PROJECT NUMBER: CDP 09-067

JOB ADDRESS: 22959 PACIFIC COAST HWY

PROJECT DESCRIPTION: New Motel, Grading, Retaining Walls, NAOWTS.  
Previously proposed as a new commercial building.

## ENVIRONMENTAL HEALTH REVIEW SHEET

SITE PLAN

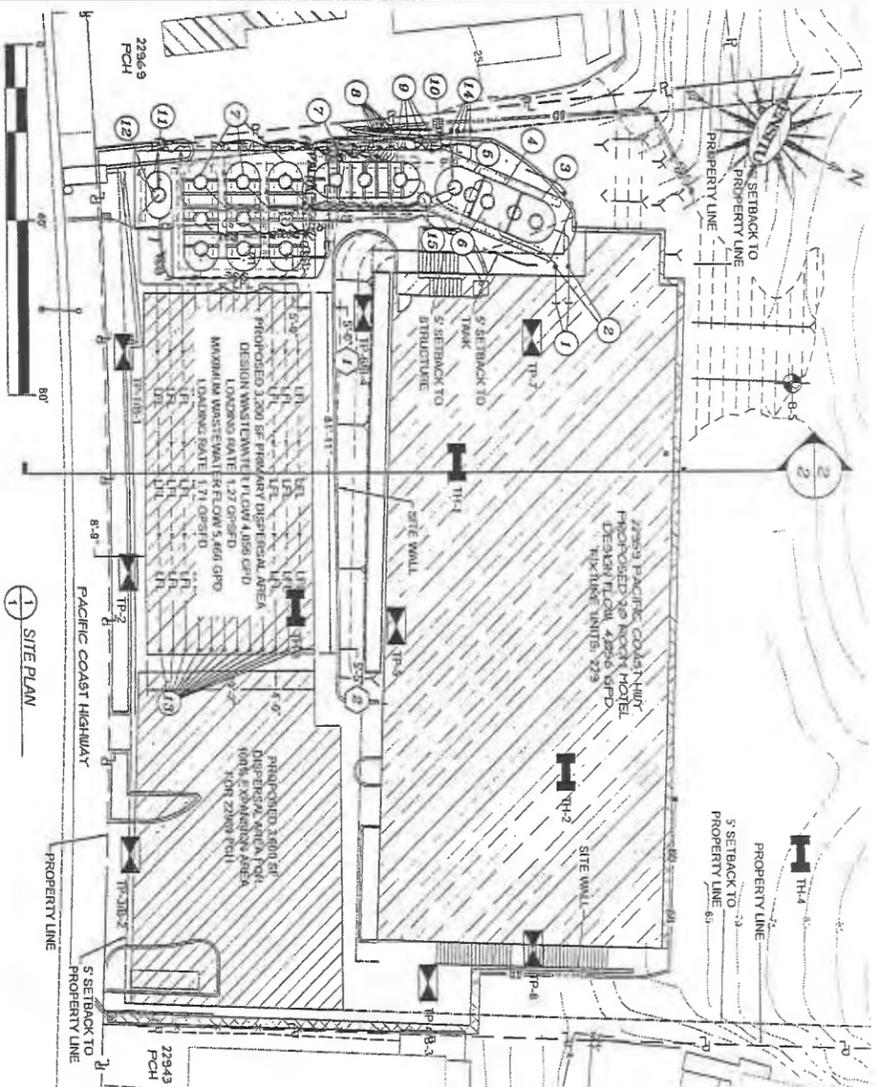
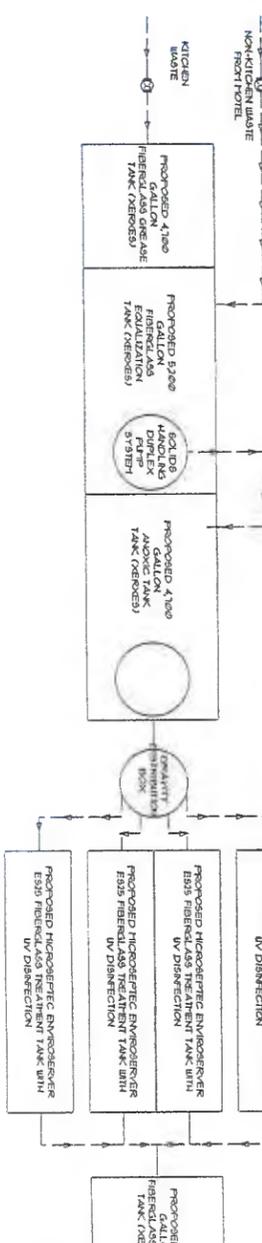
- This conformance review is for a new motel and new advanced onsite wastewater treatment system (OMTS). The new OMTS shown conforms to the requirements of the City of Malibu Municipal Code (MMC) and the Local Coastal Program (LCP).
- This conformance review relates only to the minimum requirements of the MMC, and the LCP, and does not include an evaluation of any geological or other potential problems, which may require an alternative method of wastewater treatment.
- This conformance review is valid for one year, or until MMC, and/or LCP, and/or Administrative Policy changes render it noncomplying.
- The OMTS must be maintained in accordance with the Monitoring Plan contained in the OMTS final design report by Ensite Engineering dated 2-21-19.
